Town of Lake Park Town Commission Meeting Meeting Date: February 21, 2024 PARKING CODE TEXT AMENDMENT

STAFF MEMO & PROPOSED ORDINANCE

Figure 78-142-1

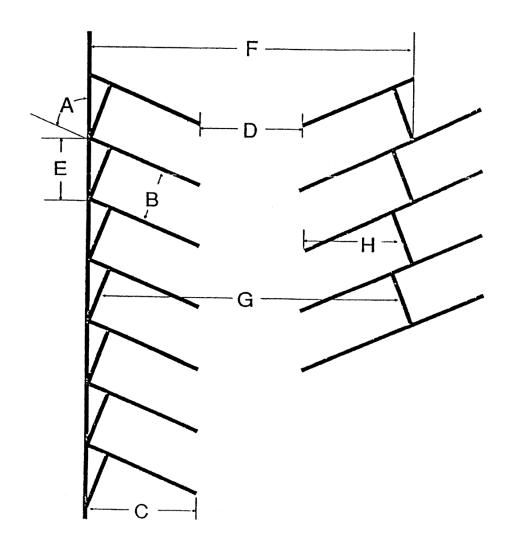
Pursuant to Town Commission feedback, staff is bringing back an ordinance for reducing the standard parking space width by 1 foot. Previously, another version of this ordinance was brought before the Town Commission including provisions for compact parking, which has been removed from this latest version. Please note parking structures are regulated separately in the code and these code changes will effect surface parking lots only, per the Commission's prior direction.

Especially as the Town pursues urban redevelopment projects, we feel a 1 foot reduction in the width of the required standard 90-degree parking space will prove beneficial for redevelopments while still providing a specification that is in keeping with other municipal and county code averages.

The substance of the code changes is detailed below. Note that the letters in the second from the top row of Table 78-142-1 correspond with the letters indicated on Figure 78-142-1, which conceptually illustrate the substance of the proposed changes.

| 60 | 10'0" | 19'0" | 14'0" | 11'6" | 53'0" | 50'0" | 17'6" | General |
|----|----------------|-------|-------|----------------|-------|-------|-------|-------------|
| 90 | <u>9</u> 10'0" | 18'6" | 24'0" | <u>9</u> 10'0" | 61'0" | 61'0" | 18'6" | General |
